**SERVICE BULLETIN**

ENGINE - FUEL AND CONTROL - DO A CLEARANCE CHECK BETWEEN THE BRACKET AND THE FUEL
NOZZLE SUPPLY MANIFOLD - CATEGORY CODE 3 - MOD.ENG-73-0042

V2500-ENG-73-0042

Inspection location fuel nozzle supply manifold (No. 18 position) to bracket clearance
Fig.1

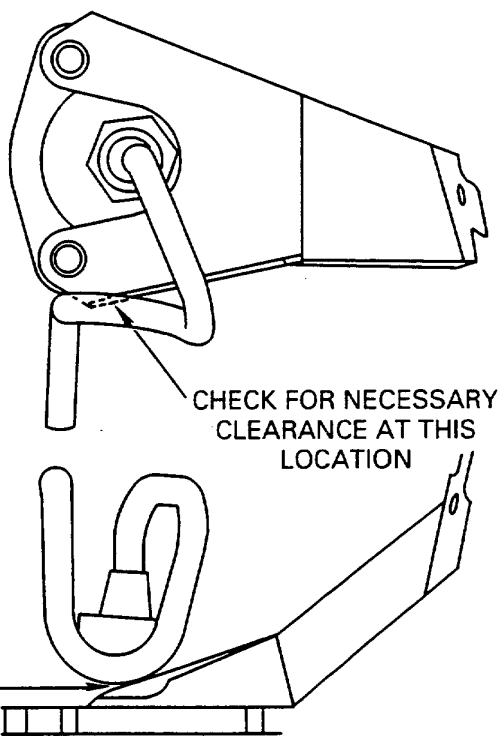
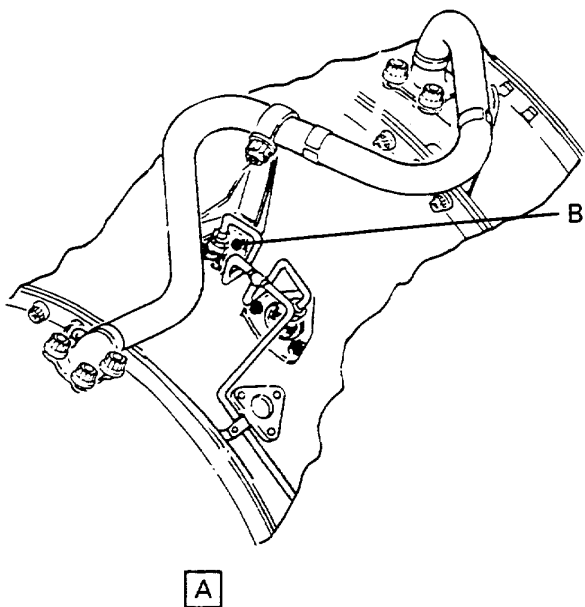
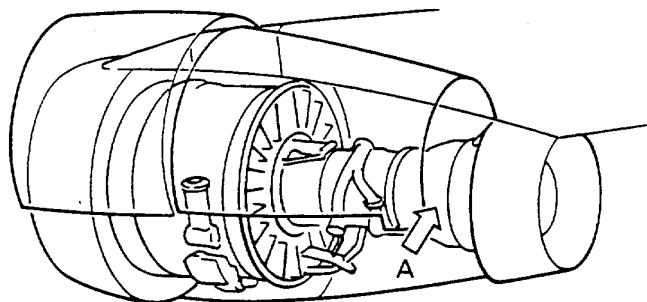
- (5) Measure and make a record of the minimum clearance between the 2A1488 Bracket and the 2A1389-01 Fuel Nozzle Supply Manifold. Refer to Figure 1.

CHECK FOR NECESSARY
CLEARANCE AT THIS
LOCATION

CHECK FOR NECESSARY
CLEARANCE AT THIS
LOCATION

- (c) If the clearance is 0.098 in. (2,489 mm) or more no further action is necessary.

- (d) If the clearance is between 0.000 and 0.035 in. (0,000 and 0,89 mm) proceed as follows:
- 1 Replace the 2A1389-01 Fuel Nozzle Supply Manifold immediately. Do the approved procedure in reference (1), Control No./TASK No. 73-11-41-400-010.

- (e) If the clearance is between 0.035 and 0.098 in. (0,89 and 2,49 mm) proceed as follows:
- 1 Replace the 2A1989-01 Fuel Nozzle Supply Manifold at the next scheduled 'A' Check, subsequent to the inspection or within 400 hours. Do the approved procedure in reference (1), Control No./TASK No. 73-11-41-400-010.

- (f) After the new Fuel Nozzle Supply Manifold is installed, do an inspection to make sure that there is a minimum of 0.098 in (2,489 mm) clearance between the manifold and the 2A1488 Bracket.
